VARIANCE REQUEST

Iowa Department of Natural Resources

1. Date: June 16, 2003
2. Review Engineer: Larry Bryant
3. Date Received: May 16, 2003
4. Facility Name: City of Eagle Grove WWTP
5. County Number: 99 (Wright)
6. Program Area: CP (Wastewater Construction)
7. Facility Type : C05 (Biological Treatment)
8. Subject Area : 401 (Flow Splitting)
9. Rule Reference: 567-64.2(9)a
10. Design Stds Ref: 14.4.9.2; 14.4.9.3; 18A.7.4.5(a) (Flexibility;
Flow Division Control; Flow Control)
11. Consulting Engr: Kuehl & Payer, Ltd.
12. Variance Rule: 567-64.2(9)c

EAGLE GROVE FLOW SPLIT

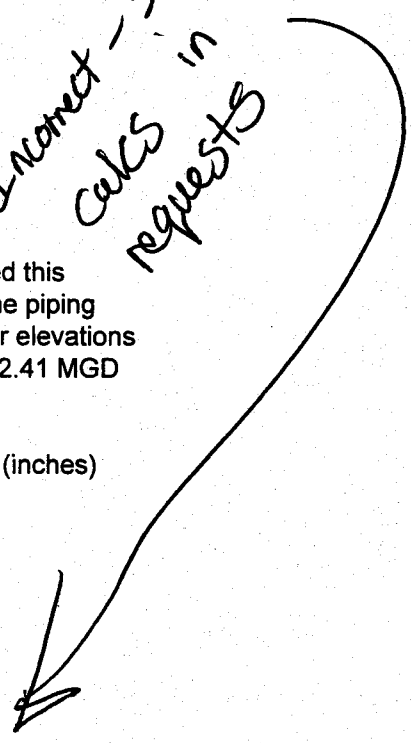
*Incorrect - see revised
calcs in variance
requests*
